**Preliminary Review Comments
of Century City Area
Fault Investigation Report
Westside Subway Extension Project
Century City and Beverly Hills, CA**

March 8, 2012

Submitted To:
Mr. Aaron Kunz
City of Beverly Hills
345 Foothill Road
Beverly Hills, CA 90210

By:
Shannon & Wilson, Inc.
664 W. Broadway
Glendale, CA 91204

Photograph 1 – South Side of “Big” Santa Monica Boulevard looking southwest along the old railroad right-of-way.

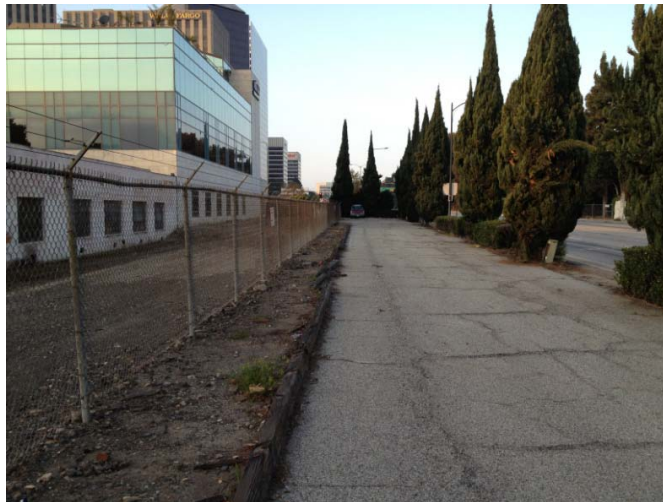
It is uncertain if the main trace of the SMFZ, or a fault splay, lies within the gap, even though maps presented in the Fault Report indicate otherwise. The Fault Report notes that the portion of the SMFZ that bends away from Santa Monica Boulevard is within an area that may have been modified by stream activity. The erosion could have modified the topographic expression of the SMFZ to make it appear that the fault curves to the north, when in actuality it could follow Santa Monica Boulevard in a more straight-line fashion until it intersects with the WBHL. As a result, there is a reasonable chance that the SMFZ crosses the gap.

Moving the station further northeast into the WBHL could be a feasible option based on our interpretation of the Fault Report data and trenching at BHHS. The Fault Report concludes that the WBHL is structurally connected to the active Newport-Inglewood Fault zone to the southeast, and therefore is also considered active. However, the recent trench mapping at the BHHS contradicts this conclusion. Also, the Fault Report geologic sections showing displacements of geologic units by the WBHL (Plate 4 of Fault Report) terminate in the Older Alluvium Sand Deposits (geologic symbol: Qfo). The unit is identified as late Pleistocene (Table 1 of Fault Report), which makes it too old to be an indicator of Holocene fault activity. This is an important issue in deciding if a fault is “active”, which relies on movement within the recent Holocene Epoch (the last 10,000 to 12,000 years).

As discussed above, we recommend that additional studies be considered to determine fault activity of the WBHL in the vicinity of Santa Monica Boulevard. An east-west fault trench could be excavated in the old railroad right-of-way on the south side of “Big” Santa Monica Boulevard as shown in Figure 2 and Photograph 1 below, to confirm the WBHL findings at the BHHS. A north-south fault trench perpendicular to the trace of the SMFZ should also be considered at the west end of the proposed station in this area to confirm the termination of the SMFZ at the WBHL. Depending on the results of these additional studies, locating the station within the currently denoted WBHL may be feasible.
